**RE: SPEX 2009-0008 – Corpus Christi Parish, SPEX 2009-0012 – Corpus Christi School,  
SPEX 2009-0013 - Corpus Christi Convent  
BCG Project #: 5171-01-001**

Below is our response to the agency referrals received concerning the subject applications:

OPEN SPACE EXHIBIT

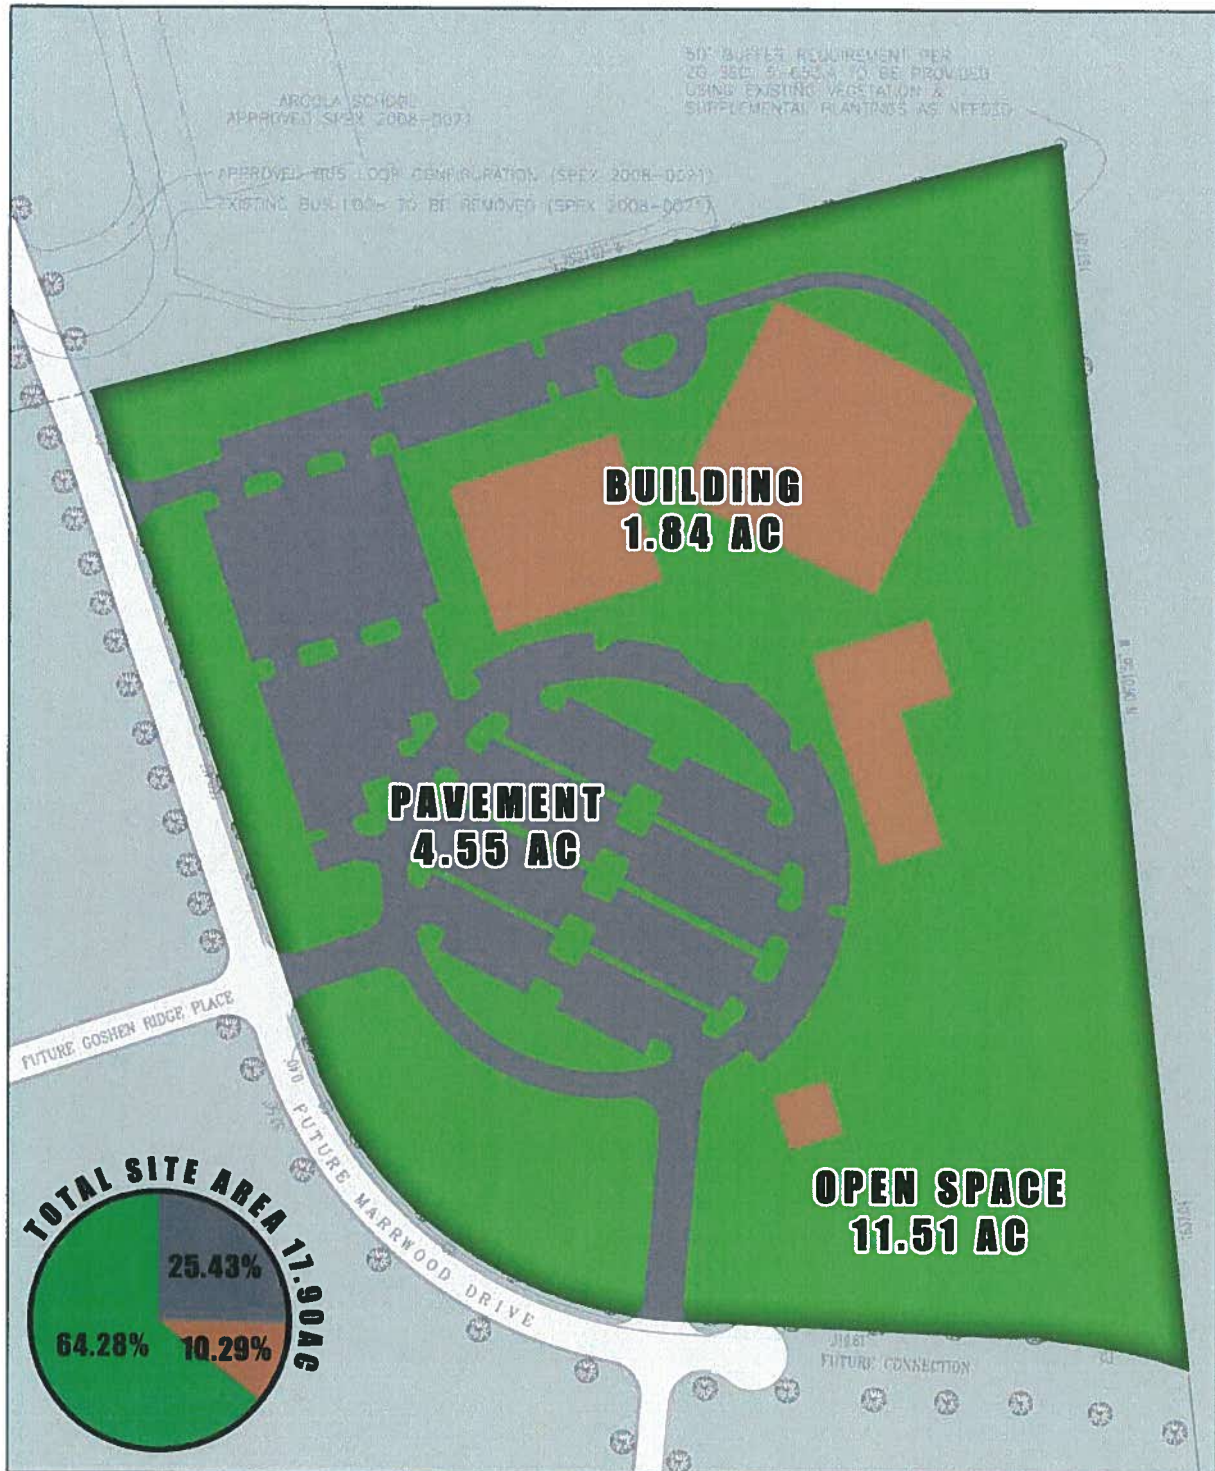
10. *"Staff recommends providing detailed information pertaining to the amount of open space being proposed and how the application is meeting the open space objectives of the Plan."*

20. *"A minimum of 50% open space shall be maintained for the TR-1UBF sub-districts. State the amount required on 17.9 acres and the amount provided in the Transition District regulation tabulation on sheet 1 and 3, Site Tabulation. (§5-701(C)(2)(d))."*

**The proposed campus layout results in open space exceeding the 50% minimum requirement of the TR-1 Zoning District. Such open space is located and configured to facilitate the desired visual integration of the Parish campus with the surrounding transitional area. In particular, the open space program includes natural buffer areas comprised of preserved vegetation along the site's north and east boundaries, landscaped setback areas, active recreation space, and formal open areas interspersed among the parish buildings combining green and hardscape elements. This combination of open space components achieves a diverse campus landscape that complements and integrates with the surrounding area, and ensures an appropriate balance between the site's developed and open areas. The attached exhibit identifies and quantifies proposed open space on the Parish campus.**

**Acknowledged. The referenced tabulations have been revised to specify the minimum open space required. Moreover, an Open Space Exhibit has been provided that delineates and quantifies the areas of open space.**
